Amendments to the Drawings

Application No. 10/812,687 filed 03/30/2004 Amendment dated 06/07/2005 Reply to Office Action of 03/07/2005

Application No. 10/812,687 Amdt. Dated 06/07/2005 Reply to Office Action of 03/07/2005 Annotated Sheet 2/2 Showing Changes

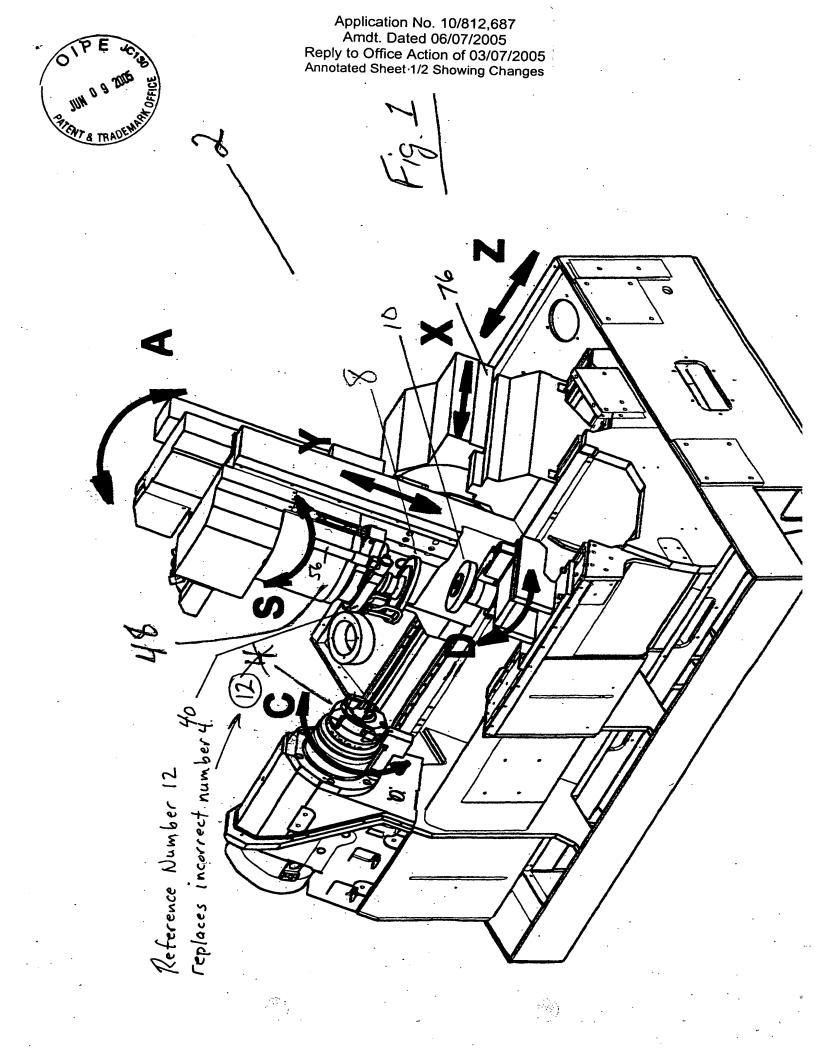
Minor changes have been made to Figures 1 and 2 (annotated sheets attached with changes shown in red). In Figure 1, the clamping mechanism was erroneously referred to as "4" when the correct number is -- 12 --. Reference number 12 is correct in Figure 2.

In Figure 2, a reference number is missing from the lead line to the outer ring portion. The number -- 4 -- has been inserted as this is the number utilized in paragraph [0018], line 3.

Also, drawing Figures 1 and 2 have been corrected to show the clamping mechanism as "12" (not "4") in Figure 1 and to include reference number "4" in Figure 2 at the location of the empty lead line. Finally, replacement formal drawings (all Figures 1-8) have been submitted in which Figures 1 and 2 incorporate the drawing changes noted above. The Examiner's approval is respectfully requested.
